219030

RE: PICTON HIGH SCHOOL REDEVELOPMENT (SSD 8640) SECTION 4.55 MODIFICATION 1 RESPONSE TO SUBMISSIONS

Figure 1 External sign elevation

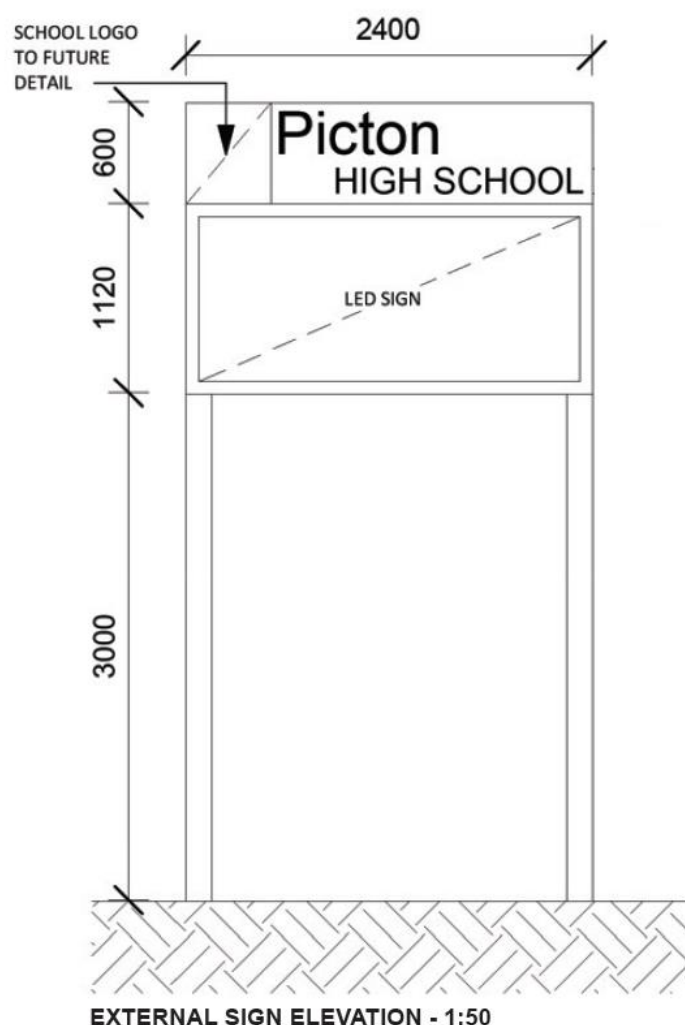
The DPE notes that the dimensions/details of the two signs proposed to be installed are provided with the application, however, no dimensioned plans corresponding to these dimensions/details have been submitted.

Architectural plans detailing dimensions and details of the proposed signs have been prepared by BLP and are available at **Attachment A**. An elevation of the proposed signage including dimensions as replicated from the plans is shown below in **Figure 1**.
